Response to Submissions and Amendments to Proposed Development

Sydney International Convention, Exhibition and Entertainment Precinct

The Haymarket

Submitted to Department of Planning & Infrastructure
On Behalf of Lend Lease (Haymarket) Pty Ltd

Figure 9 – Illustrative scheme partial section

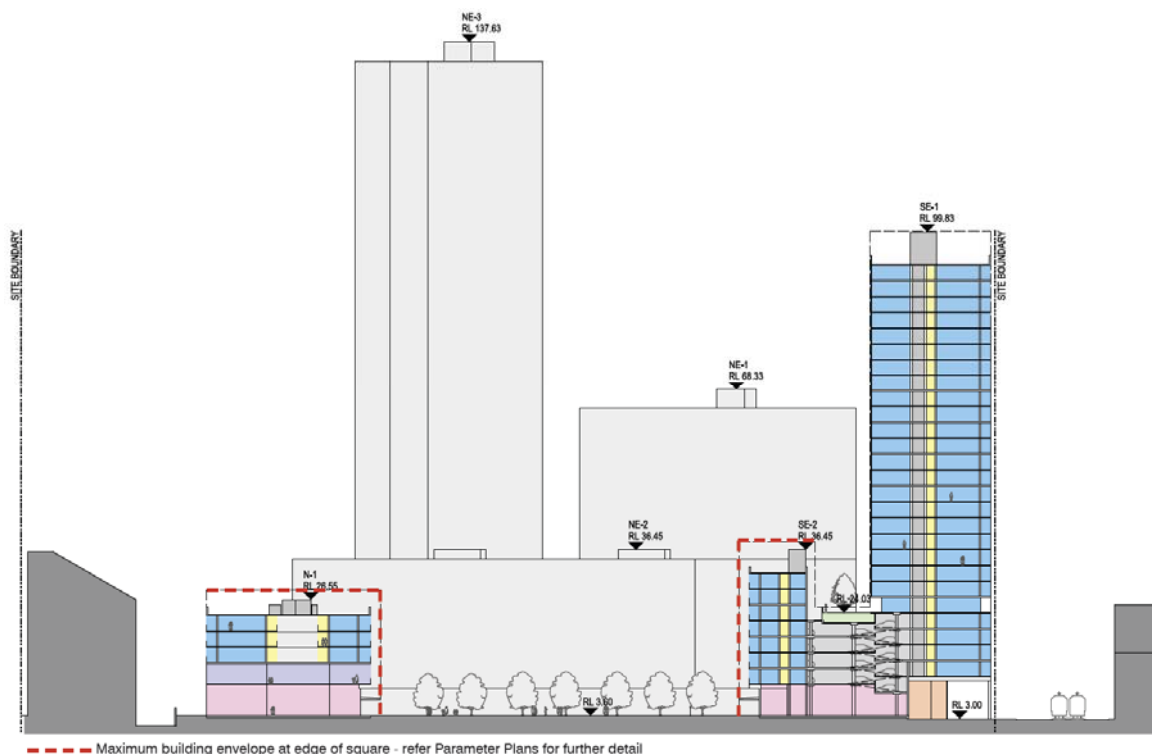
The maximum building envelope proposed to the edge of the square allows for lift overruns and plant enclosure on the roof of these buildings. The Illustrative Scheme indicates a parapet height that is lower than the current maximum building envelope, with rooftop plant setback to minimise the visual impact (refer to **Figure 9**). This will reduce overshadowing of The Boulevard and Haymarket Square, and will maximise the amenity of these new public spaces.

Updated shadow studies have been included at **Appendix H** which show the difference between the maximum building envelope and an illustrative scheme massing. Further, SSDA5 has recently been submitted with the podium height (facing the square) being below the parameter plan.

Figure 10 – Examples of car park screening

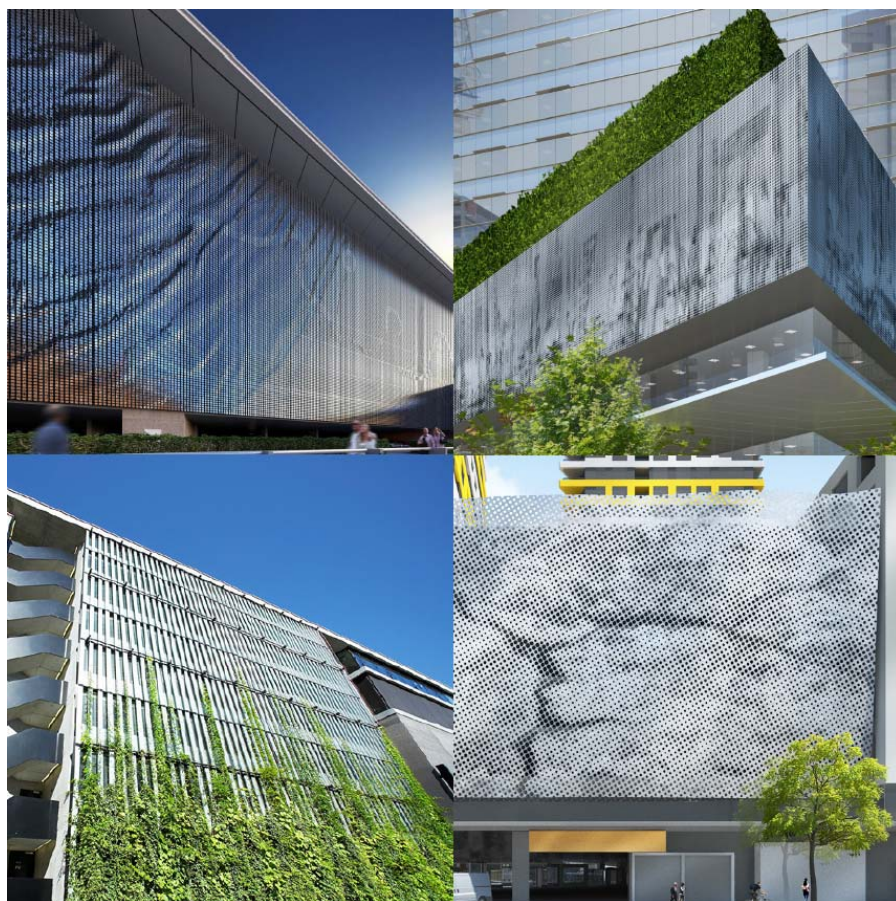
Skinning of exposed above ground carparking has already been provided in the detailed Stage 2 SSDA for the SW podium which has been lodged (SSDA5). Whilst limited above ground parking is proposed in the Stage 2 SSDAs that have already been lodged, those that do incorporate it have been skinned with high quality architectural decorative features. Lend Lease will continue to skin above ground parking on other residential plots, however there is limited capacity to do so with the public car park.

Examples of screening for above ground parking are provided at **Figure 10**.

Figure 14 –Extent of offered external public domain works

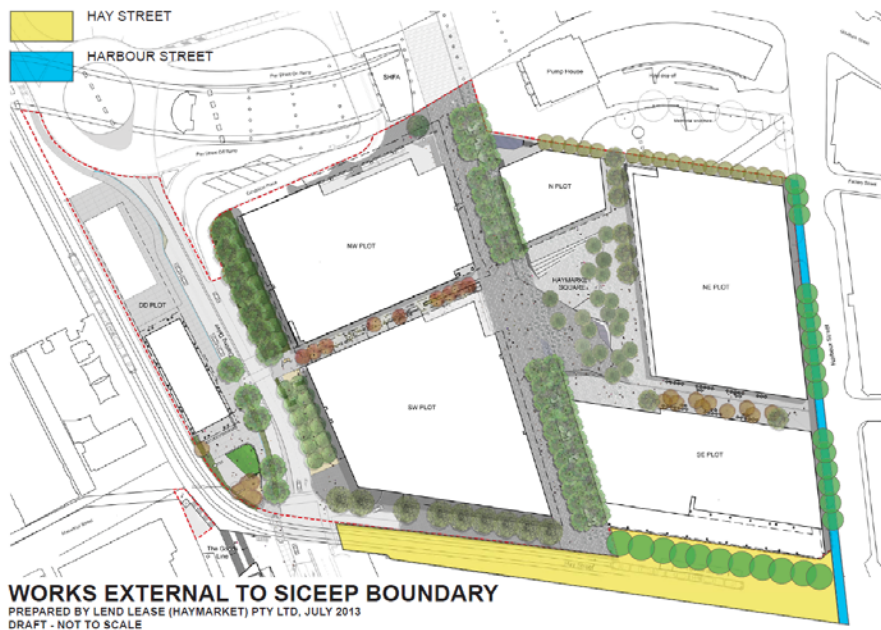
All infrastructure and public domain works within the SICEEP site will be undertaken as part of the SICEEP project. Consultation with the City will be undertaken to ensure that the interfaces with areas external to the site are seamless and in line with the works planned by the City. In this regard Lend Lease agree that the upgrade of Hay Street and Harbour Streets is appropriate, and propose to undertake the following works (refer to **Figure 14**):

- Paving and tree planting to upgrade Hay Street outside of the site between the Boulevard and Harbour Street; and
- works to upgrade the western pedestrian pavement of Harbour Street to the kerb lin.

Figure 15 – Little Hay Street – with line of sight from Dixon Street into Haymarket Square

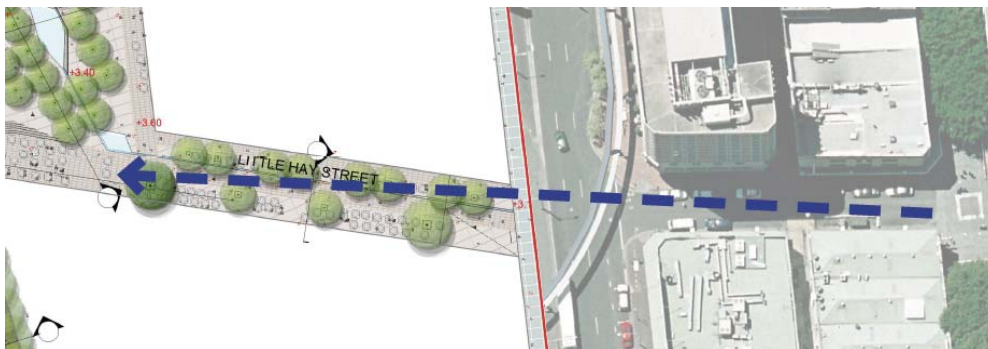
Continuation of Little Hay Street on axis into the new square

Further, the slight change in the geometry of Little Hay Street still affords a clear line of sight into Haymarket Square from Dixon Street (refer to **Figure 15**). It is a reasonably wide street, with the public domain seeking to create a more intimate environment to build upon the character of the Chinatown 'laneways'.

Figure 22 – Diagram showing alignment and visual connectivity to Powerhouse Museum

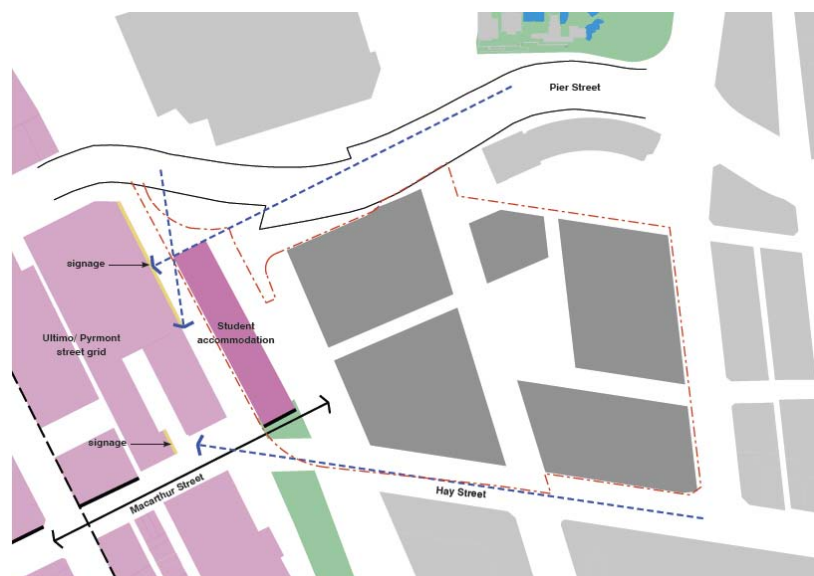
- Section(s) indicating the change in land level and heights; and
- An examination of the nature of the Powerhouse's unbuilt spaces and whether any amenity spaces (i.e. open space for active/passive recreational use) would be overshadowed.

When viewed from the Pier Street overpass (additional vantage point 2) the proposed student accommodation building envelope will partially encroach into the view of the eastern façade of the Powerhouse Museum. A significant portion of the eastern façade of the Powerhouse Museum will however remain clearly visible to both pedestrians and motorists when travelling along Pier Street to the west (refer to **Figure 23**). When moving along Pier Street to the west, views of the rear of the Powerhouse Museum progressively open up. There is a clear and distinct separation between the proposed student accommodation built form and the Powerhouse Museum, that allows for appropriate views and vistas to the building. It is considered that the relationship of the northern end of the student accommodation building in terms of setback ensures that good visual connectivity is maintained in terms of line of sight to the Powerhouse Museum.

Figure 25 – Amended site boundary

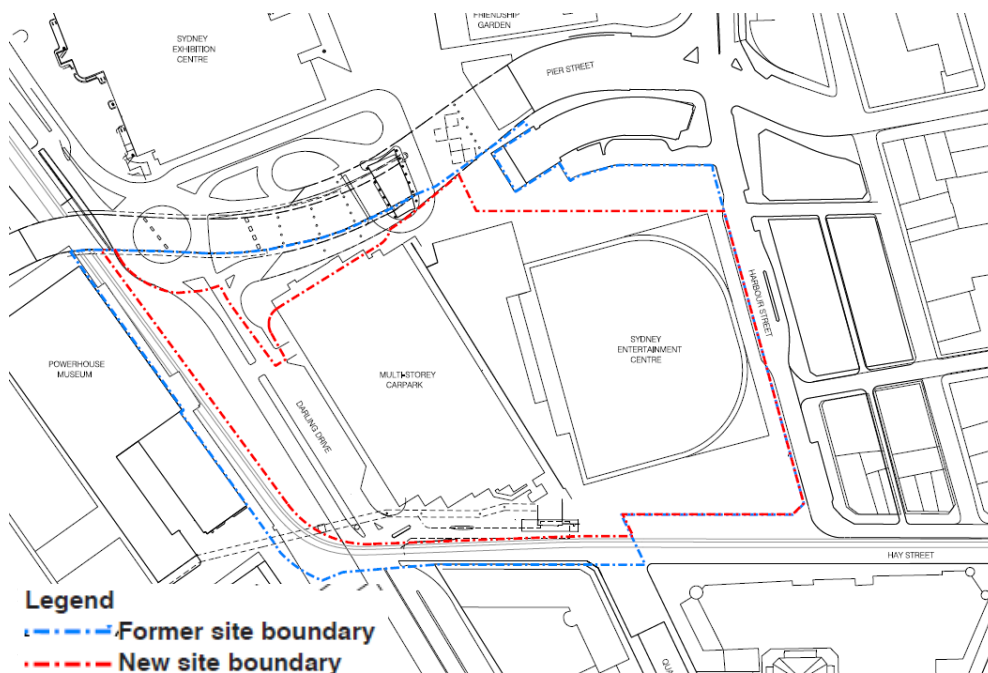
The site boundary of The Haymarket concept proposal has been amended principally to exclude Exhibition Place which now sits within the site of SSDA 1 (the PPP component of the project). This proposed amended site boundary is shown on **Figure 26**. The amendment has been a logical boundary adjustment as the works involved to redesign the Darling Drive/ Pier Street junction and revised vehicle access into the site now falls within a single site boundary and SSDA.

As amended the boundary of The Haymarket concept proposal SSDA 2 has a total area of 37,696m² (previously it was 43,880m²). With a total GFA of 197,236 m² this results in a maximum FSR for the proposed development of 5.2:1.
